Subject: Dresden Station Unit 3
 Reload No. 3 Licensing Submittal
 Supplement C
NRC Docket No. 50-249

Dresden Unit 3 - Reload No. 3 Licensing Submittal
Supplement C
Response to Letter from D. L. Ziemann dated May 12, 1975

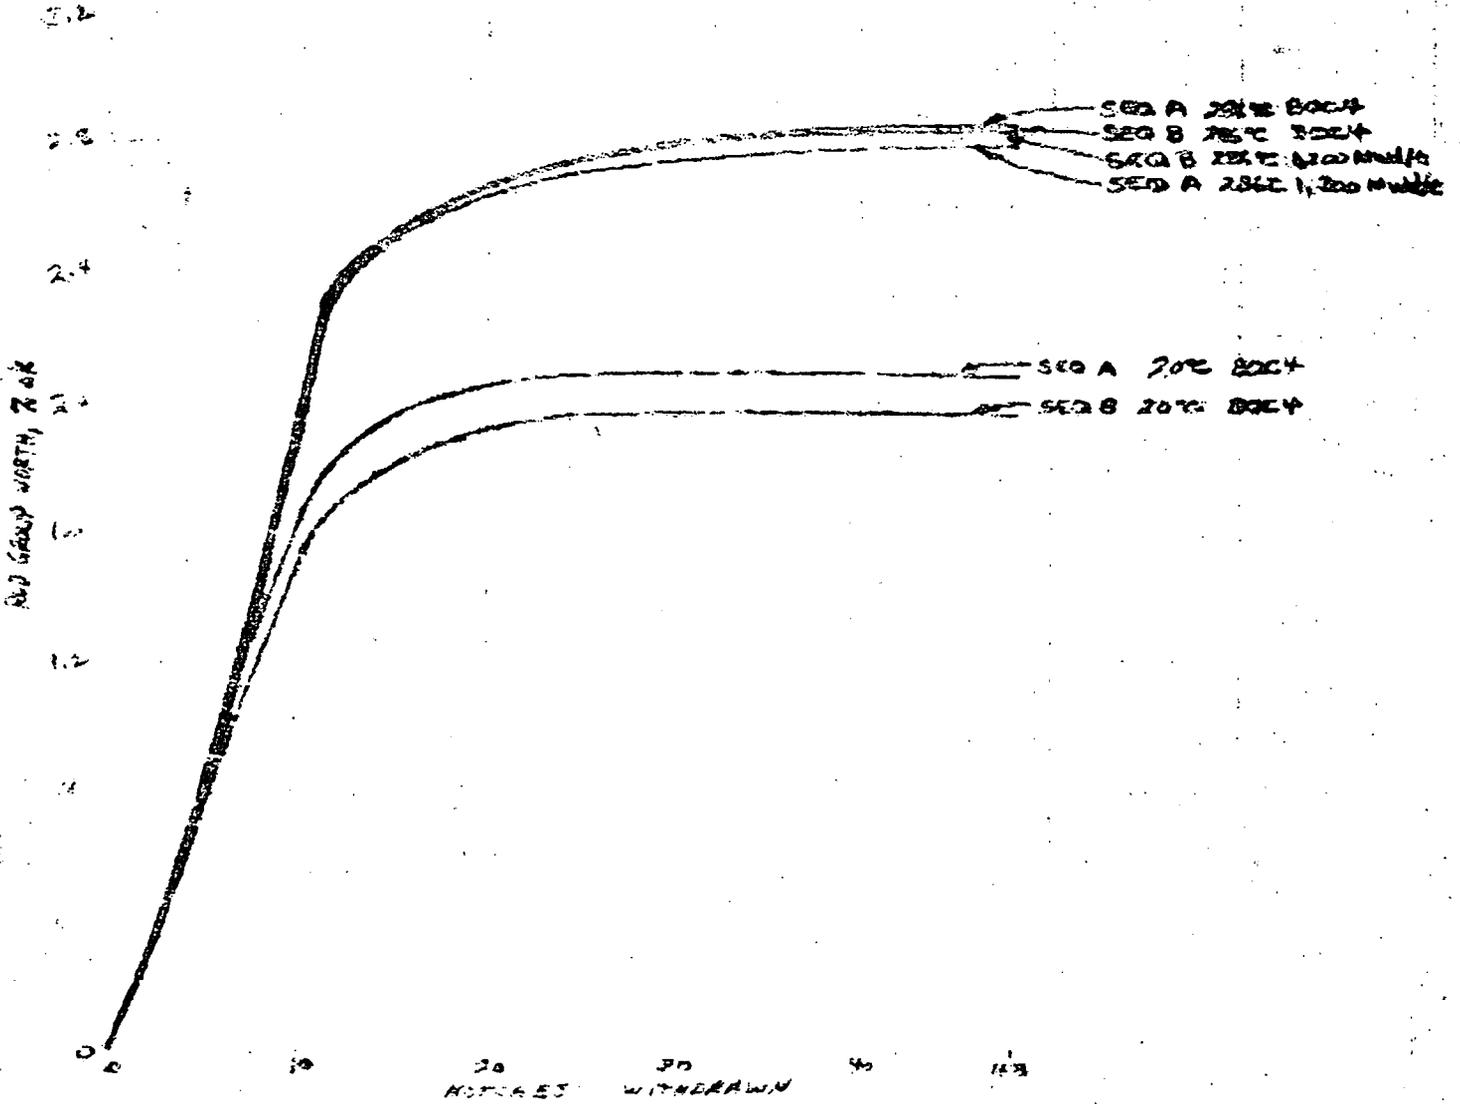
The accident reactivity characteristics for the rod drop accident shown in Figure 6-2 of NEDO-20694 imply segment rod withdrawals. This corresponds to a changing philosophy in the rod withdrawals previously established for Dresden Unit 3. Provide a thorough explanation and discussion of rod withdrawal sequences and patterns if different than previously reported to the NRC.

With the banked rod positions defined above, all the possible single rod drops for both cold and hot standby conditions were analyzed to find the cases which resulted in the greatest reactivity addition in the hot standby condition and in the cold condition. The rod drop which resulted in the maximum reactivity addition in the cold condition was found to occur at the BOC with groups 1 and 2 withdrawn in sequence B when control rod 26, 31 is dropped to the first banked position (the position of its drive). The resulting worth curve is shown in Figure 6-2 of NEDO-20694. The rod drop which results in the greatest reactivity addition with hot standby conditions was found to occur when groups 1 and 2 in sequence B are fully withdrawn and group 3 is at the second intermediate banked rod position with the exception of rod 26, 31 which is assumed to be detached from its drive and to fall from fully inserted to fully withdrawn. The resulting worth curve is shown in Figure 6-3 of NEDO-20694.

Withdrawal by banks does provide a valid technique for limiting rod worths; however, the process requires additional time for reactor startup. For this reason, Commonwealth Edison undertook a somewhat more extensive analyses of rod worth to allow reactor startup using only full rod withdrawal sequences through the fourth rod group, i.e., black and white rod pattern. The technique used for these analyses is summarized below. From these analyses, rod withdrawal sequences have been developed using full rods and smaller subgroups which ~~man-~~mizes the rod drop accident worth to a maximum of 0.013 ΔK supercritical.

The maximum worth rod in group 3 and 4 is determined for as-loaded core. If any rod within the group is $\geq 1.3\% \Delta K$, that group is subdivided until the maximum worth rod within the subgroup is $< 1.3\% \Delta K$. These subgroups are programmed into the RWM. The analysis is done at hot 0 void conditions.

Attached are two figures based on calculations which have been performed with the Dresden Unit 3 cycle 4 design reference loading pattern which demonstrates that the worth of the group 3 and group 4 rods are greater at 0 voids, 286°C conditions than at 20°C conditions. These group worth calculations were performed for both sequence A and sequence B at several cycle exposures as noted in the figures.
